NRC Clarification Questions for CH2M Hill Contractors Regarding the West Valley Demonstration Project Main Plant Process Building Demolition Modeling

- **WVDP-605:** Estimated Radiological Air Emission During Open-Air Demolition, Main Plant Process Building
- **WVDP-606:** West Valley Demonstration Project Main Plant Process Building, Main Plant Process Building Radionuclide Inventory for 40 CFR 61 Subpart H
- **WVDP-607:** Air Dispersion Modeling for Open-Air Demolition, Main Plant Process Building

Figure 1 Main Plant Process Building Inventory for Select Areas

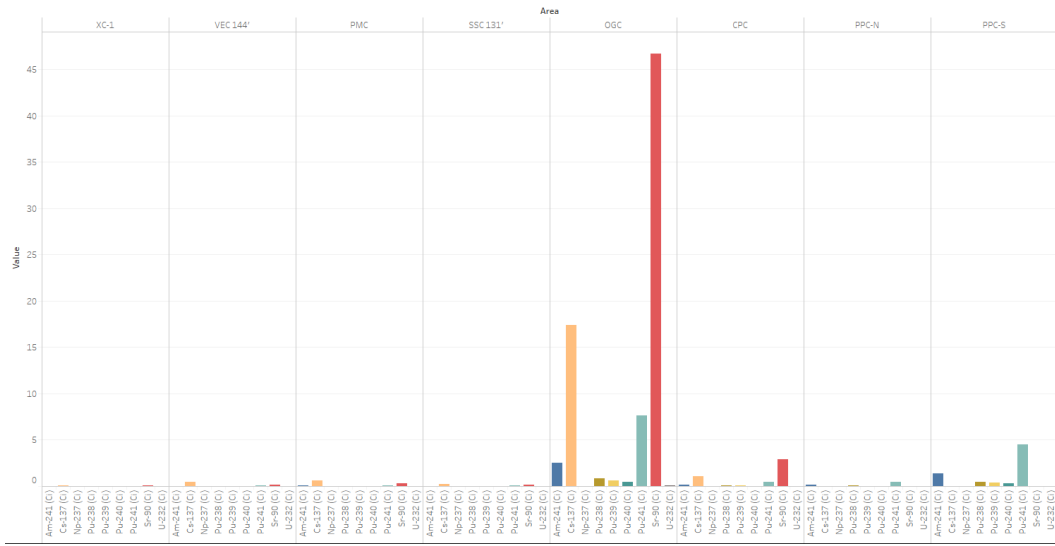
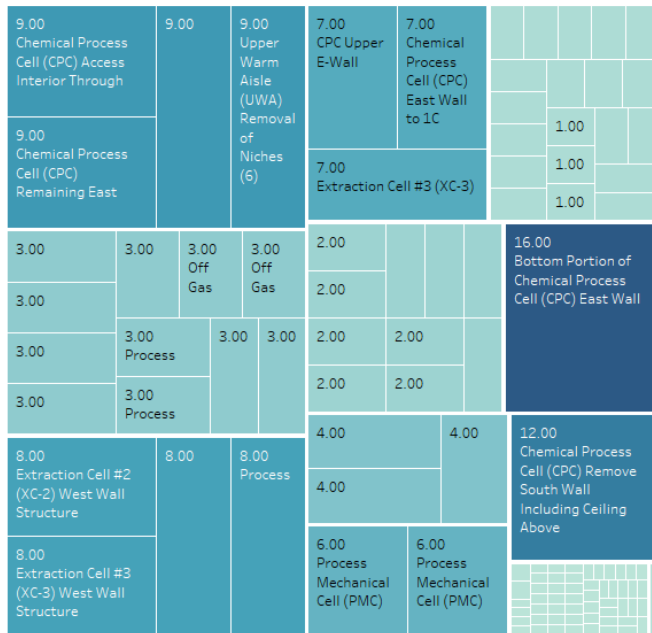
3. **Information about key risk drivers would also be beneficial to help NRC focus on the most risk-significant activities.** For example, the data provided in the figures below shows that certain activities, areas, or key radionuclides may drive the risk (e.g., concrete saw, hot cutting; extraction cell, hot cell, off gas cell). CAP-88 modeling shows that Am-241 and Cs-137 seem to be the risk drivers for member of the public doses. Information on key risk drivers based on the AERMOD modeling results would also be useful to NRC staff.
